ENGINEERING CHANGE NOTICE

Proj. ECN W-105-172

2. ECN Category (mark one)	3. Originator's Name, Organization, MSIN, and Telephone No.		4. Date
Supplemental ☒	K.L. EWER, KEH, E6-04, 6-1294		3-19-92
Direct Revision ☐	5. Project Title/No./Work Order No. W-105/ 242-A EVAP RETTN BASINS	6. Bldg./Sys./Fac. No. 242-AL	7. Impact Level / SC 3EQ / 3
Change ECN ☐			
Temporary ☐			
Supersedure ☐	8. Document Number Affected (include rev. and sheet no.) SEE BLOCK 12	9. Related ECN No(s). SEE BLOCK 12	10. Related PO No. N/A
Discovery ☐			
Cancel/Void ☐

13a. Justification (mark one)	13b. Justification Details
Criteria Change ☒	ITEMS 9, 12-17; LOI 93 - DIRECTS KEH TO PROVIDE LEAK DETECTION INSTRUMENTATION AT CATCH BASINS WITH LOCAL ANNUNCIATION & ALARM AT 242-A EVAP.
Design Improvement ☐	
Environmental ☐	
As-Found ☐	ITEMS 1-8, 10-19; LOI 95 - PROVIDE CONTINUOUS LIQUID LEVEL INSTRUMENTATION FOR BASINS (6" NORTH SAMPLE PORT RISER) AND LEACHATE SUMPS (4" LEACHATE RISER) WITH LOCAL READ-OUT & 242-A ALARMS
Facilitate Const. ☐	
Const. Error/Omission ☐	
Design Error/Omission ☐

KAISER ENGINEERS HANFORD	ENGINEERING CHANGE NOTICE SKETCH					
Ref. Dwg.	Sh.	Rev.	Prepared By	Checked By	ECN No.	Page
H-2-79649	1	0	K.L.EWER	[illegible]	W-105-172	10/22

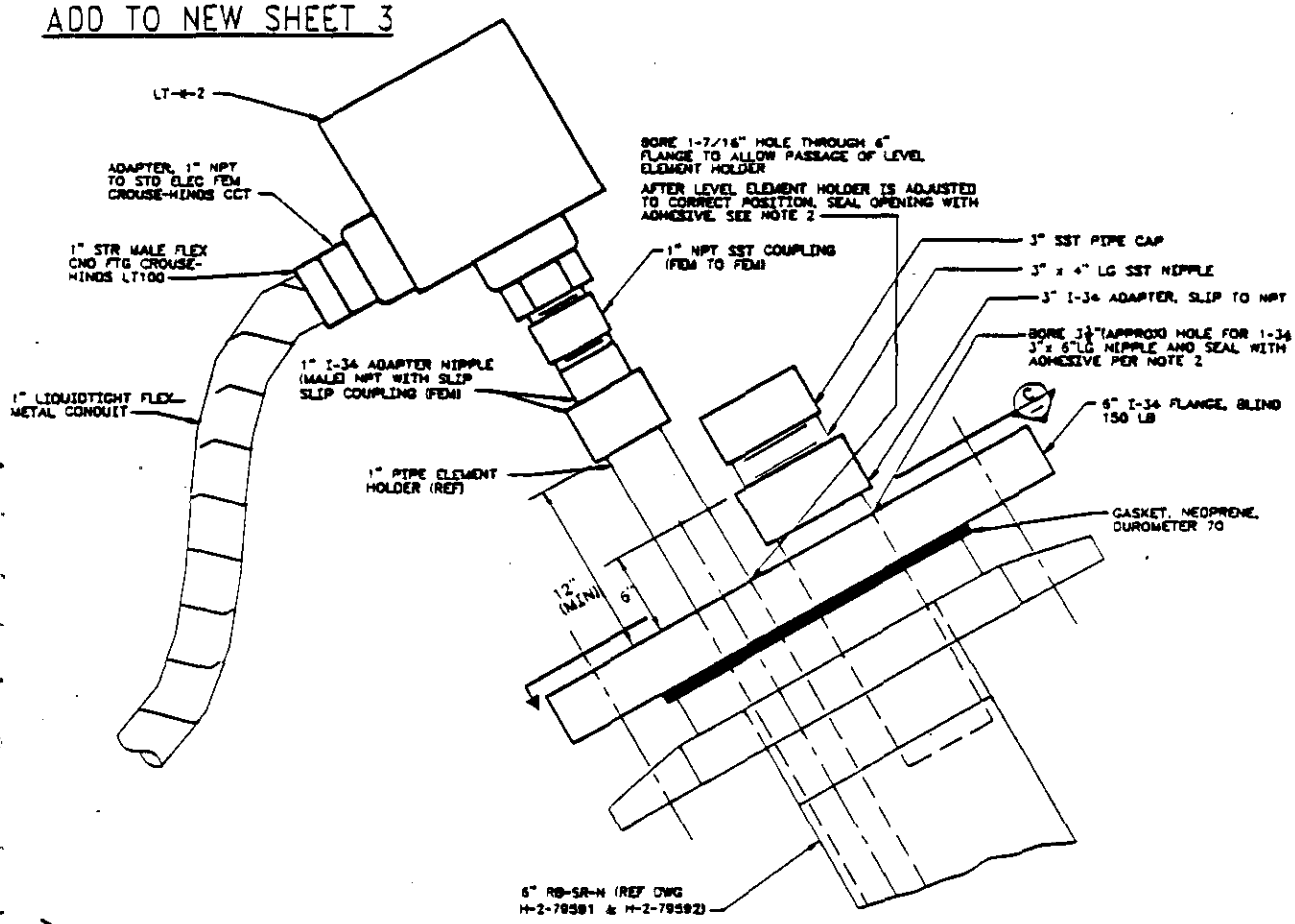
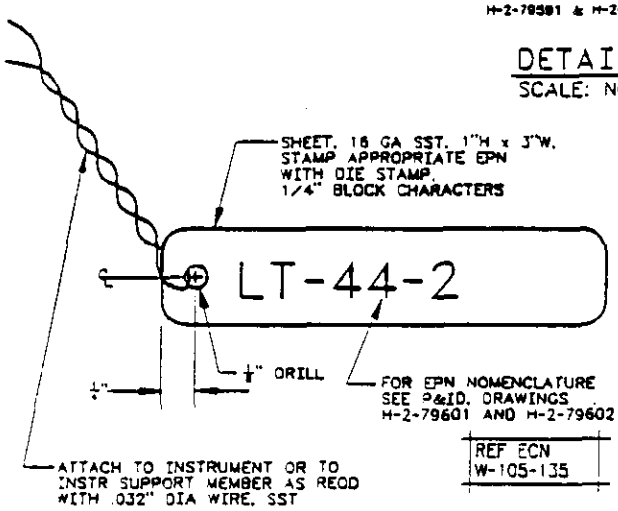
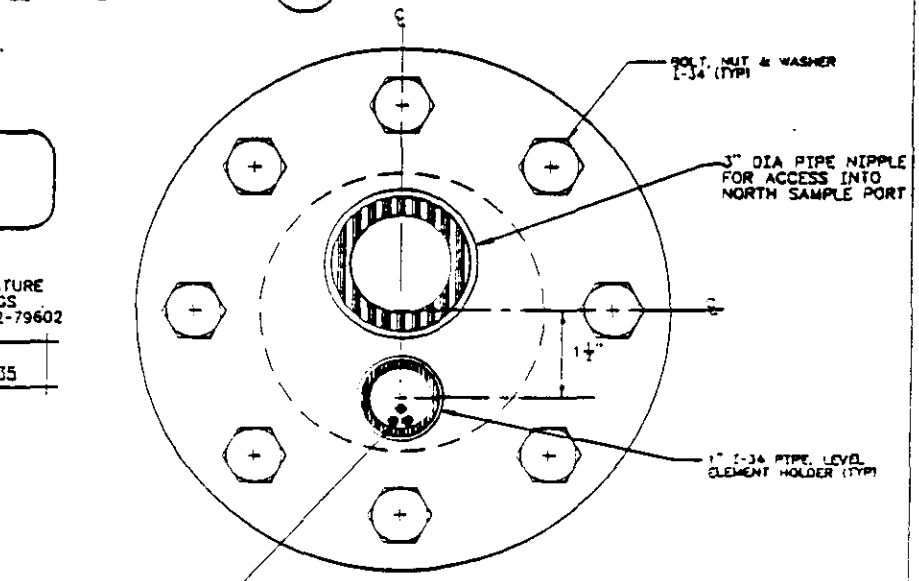
6. TITLE BLOCK & INSTL DETAIL PER PAGE 8.
7. DETAIL 6 PER PAGE 9.
8. DETAIL 5, DETAIL 10 AND SECTION C PER PAGE 10.
9. BASIN LEVEL INTERCONNECTION DIAGRAM PER PAGE 11.
10. DETAIL 7 CATCH BASIN LDE MOUNTING PER PAGE 12.
11. DETAIL 8 LEACHATE/BASIN LEVEL IND PER PAGE 13.
12. ADD REFERENCE TO TITLE BLOCK REFERENCES AT ZONE A4; "HPS I-2-7 HANFORD PLANT STANDARD - EQUIPMENT NAMEPLATES"
13. TABLE I AND TABLE II PER PAGE 22.

ADD TO NEW SHEET 3

DETAIL 5
SCALE: NONE

DETAIL 9
SCALE: NONE
SH 1, 2 & 3

TAG ALL FIELD INSTR CONSPICUOUSLY EXCEPT FOR THOSE ALREADY HAVING EQPT NAMEPLATES

SECTION C
SCALE: NONE

TYP - CONTINUOUS BASIN LEVEL INTERCONNECTION DIAGRAM

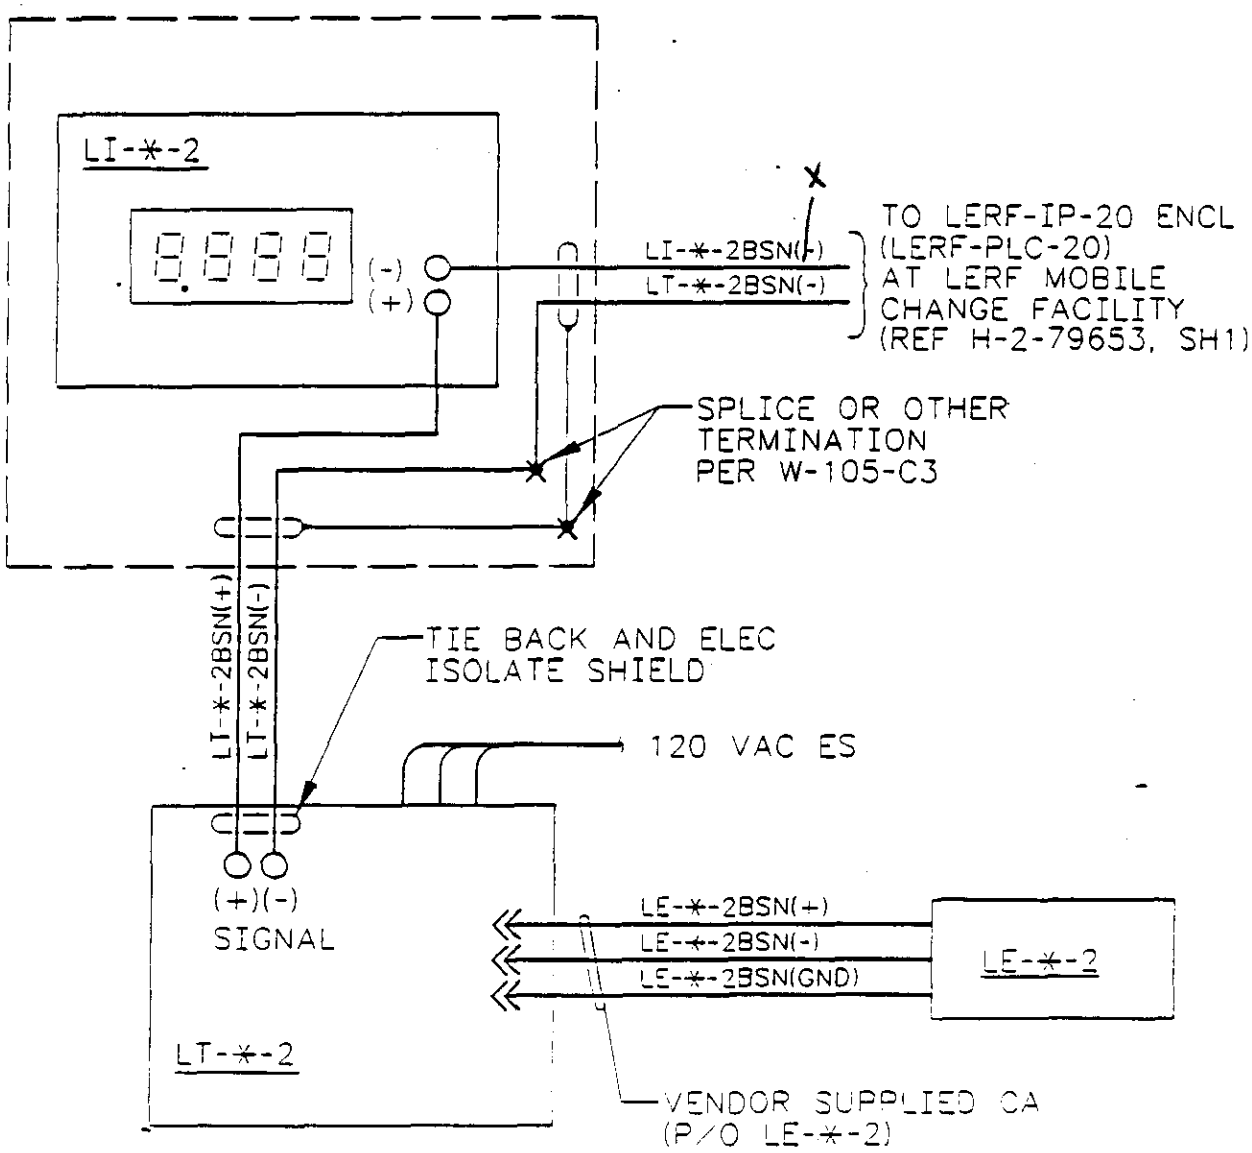
ADD TO NEW SHEET 3

DETAIL 7
SCALE: NONE

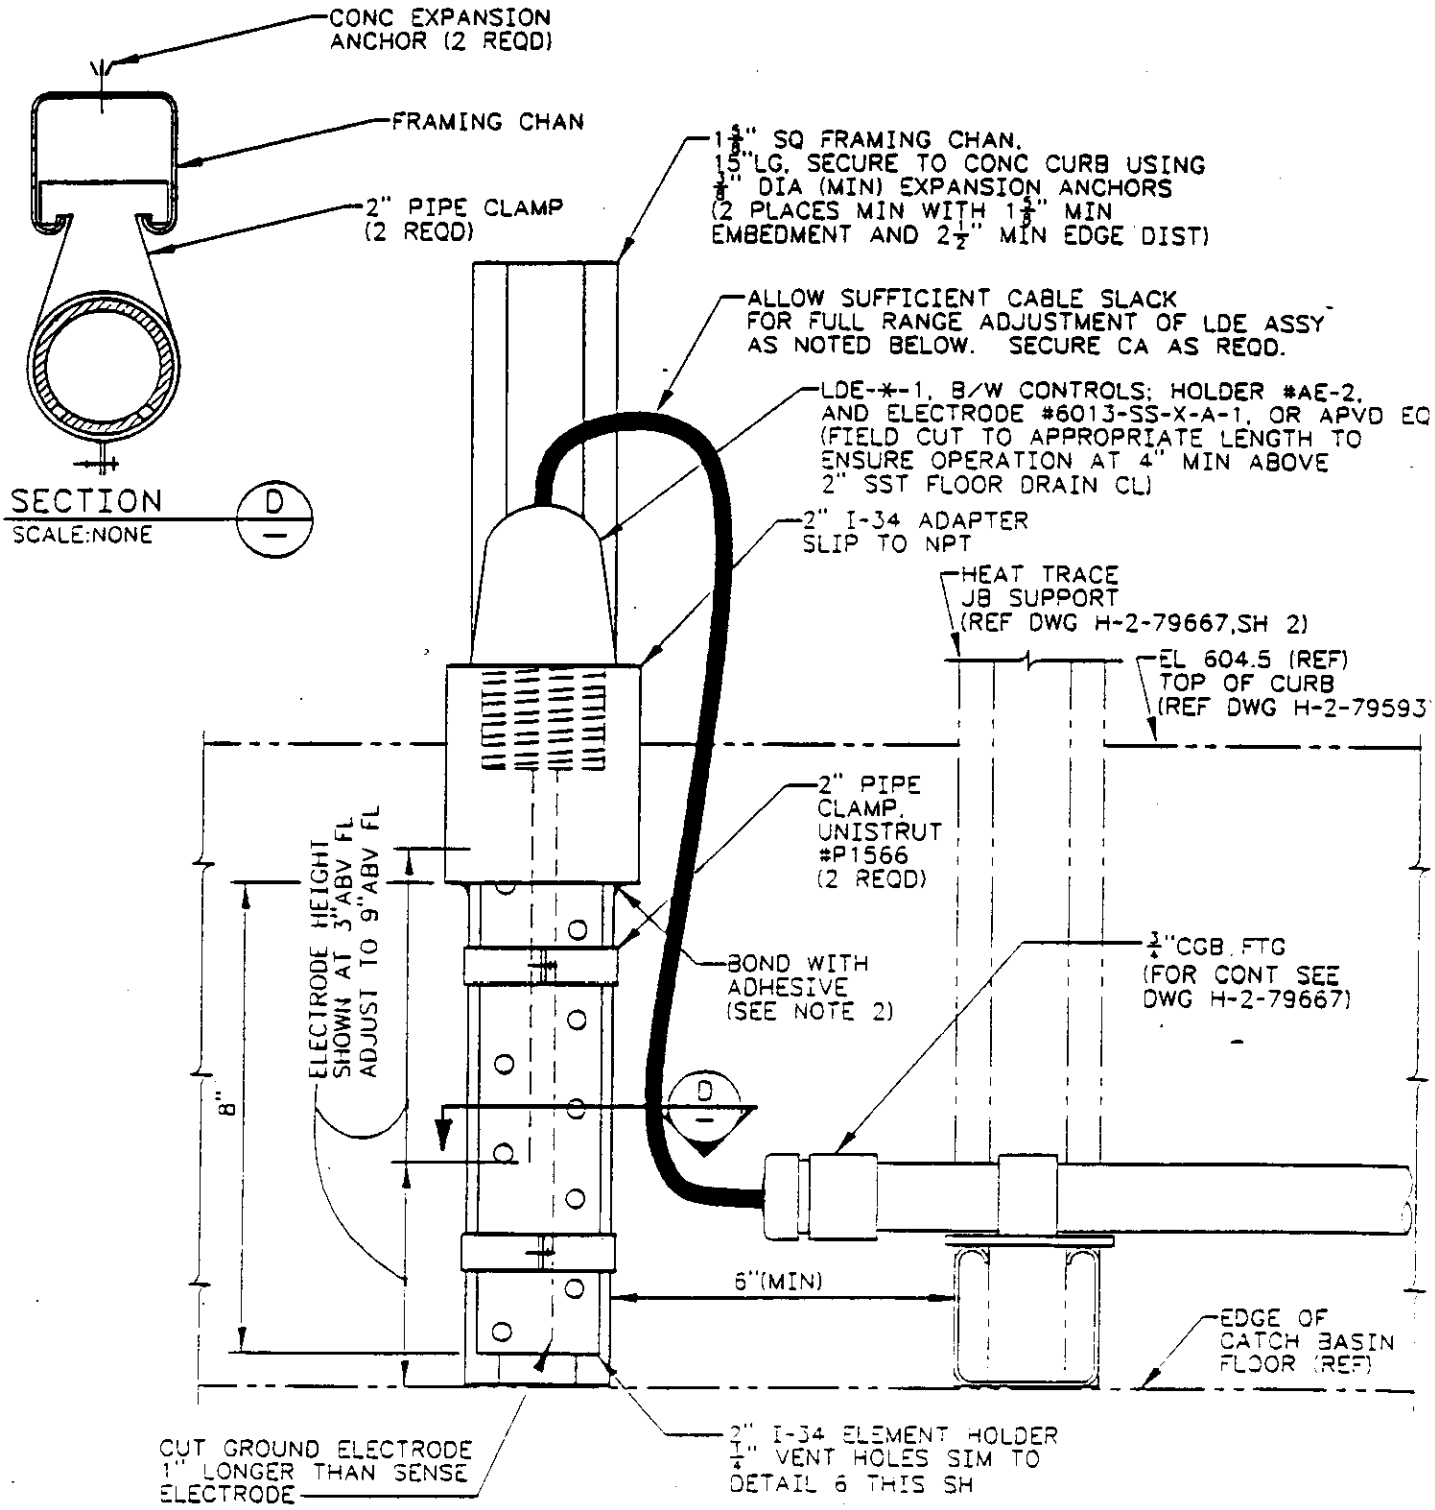
ADD TO NEW SHEET 3

TYP - CATCH BASIN LEAK DETECTOR MOUNTING

DETAIL 8/—

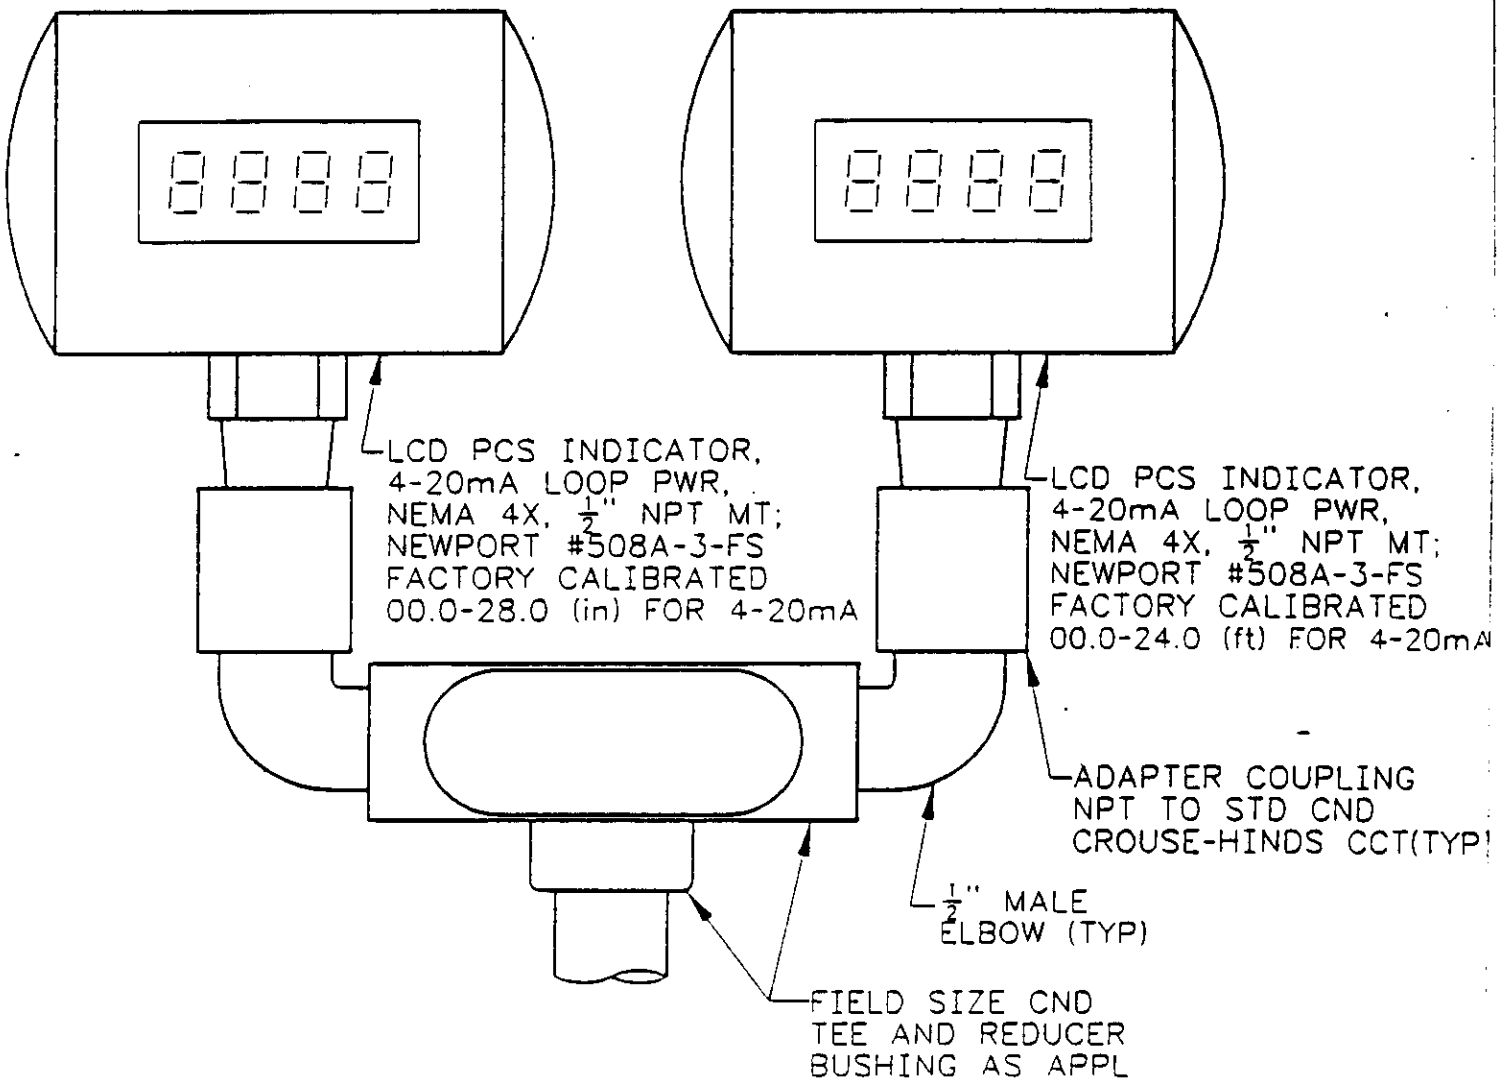
ADD TO NEW SHEET 3

NAMEPLATE ATTACHED TO BACKPLATE; PER HPS I-2-7, SIZE 'C' ($\frac{3}{4}$"x 3"L) WITH $\frac{5}{32}$" HIGH LETTERS ENGRAVE AS NOTED BELOW (TYP)

LI-*-1 LEACHATE LVL (in)	LI-*-2 BASIN LVL (ft)
* - SUBSTITUTE BASIN: 42, 43, 44	* - SUBSTITUTE BASIN: 42, 43, 44

TYP-LEACHATE/BASIN LEVEL INDICATORS

(FIELD LOCATE AT ELEC BACKPLATE REF ELEVATION 'H', DWG H-2-79667)

DETAIL 3 SH 1
SCALE: NONE
COVER SHOWN OPEN AND ROTATED TO EXPOSE BOX INTERIOR ARR

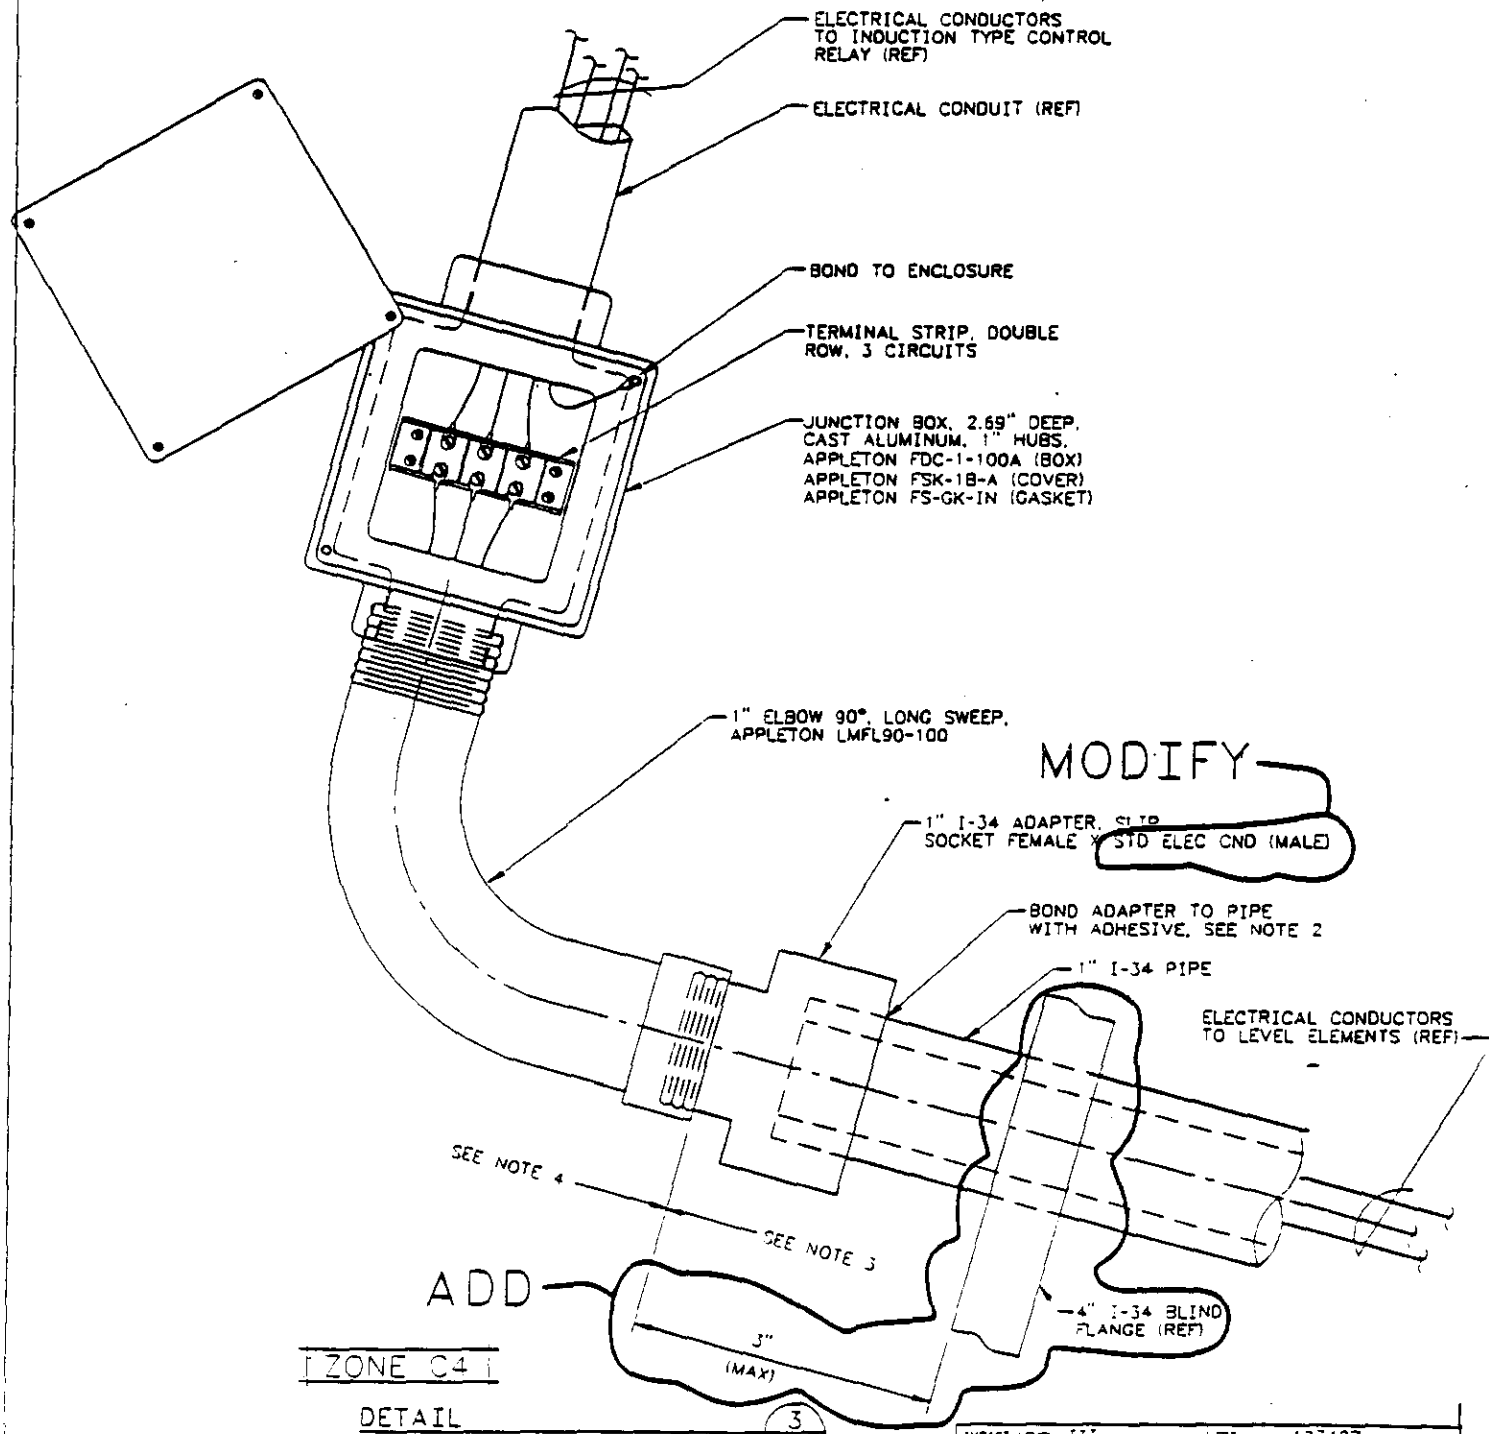
14. REVISE TITLE BLOCK & DETAIL 3 PER PAGE 14.
15. REVISE LEACHATE LEVEL INTERCONNECTION DIAGRAM PER PAGE 15.

MODIFY
